## PRODUCT SAFETY RECALL

**SUBJECT:** Second Row Safety Belt Interference When Seat Back Returned to Upright Position

**MODELS:** 2009-2010 Buick Enclave  
 2009-2010 Chevrolet Traverse  
 2009-2010 GMC Acadia  
 2009-2010 Saturn OUTLOOK

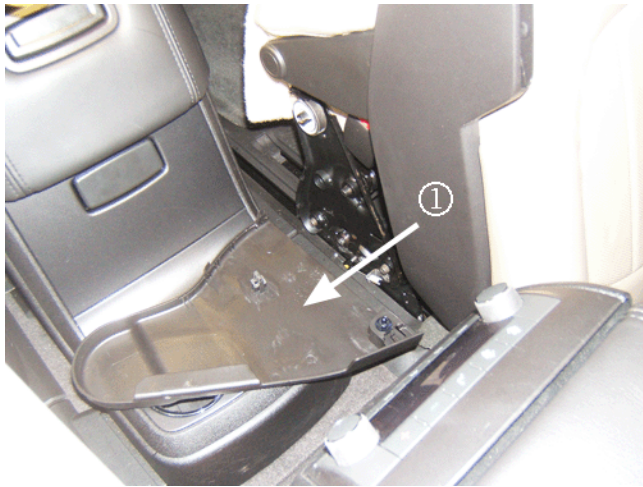
2. Verify proper functioning of the belt buckles and visually inspect each buckle/release button for damage. Refer to the illustration for an example of a damaged buckle.
  - If evidence of buckle damage such as a bent or cracked plastic housing is found, or if stressed witness marks are visible on the housing, replace the seat belt buckle. Refer to *Rear Seat Belt Buckle Replacement* in SI, and then continue on and complete the trim cover rework procedure below.
  - If no buckle damage is found, complete the trim cover rework below on the seat(s)

2509077

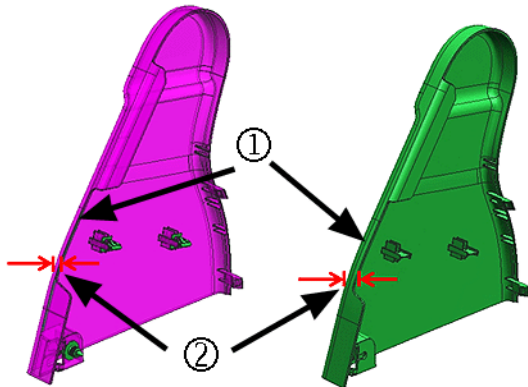
3. Remove the rear seat recliner inner trim cover (1). Refer to *Rear Seat Recliner Outer Finish Cover Replacement - Inboard* in SI.

**Note:** The material to be removed is the standing ledge (1) in the notched-out opening, shown in the examples above. Depending on the design and seat configuration, approximately 3–5 mm (0.120–.200 in) of material (2) will need to be removed.

2509078

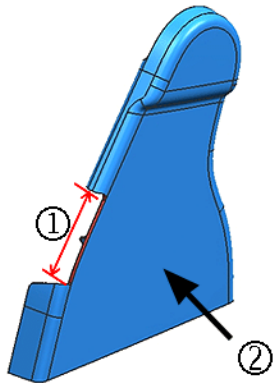
4. Using a DREMEL®, cut-off wheel, or similar tool, grind off/remove the cover's standing ledge material in the notched-out opening.

**Note:** Maintain the original notch out width (1) of approximately 82 mm (3.230 in) and remove the material until the surface edge is even with the vertical wall surface (2).

5. After the material has been removed, file down any jagged edges or corners that may tend to snag the buckle material.
6. Reinstall the rear seat recliner inner trim cover. Refer to *Rear Seat Recliner Outer Finish Cover Replacement - Inboard* in SI.
7. After the rework and installation of the trim cover, verify proper function of the seat assembly.
8. Complete the rework on the trim cover for the opposite seat.
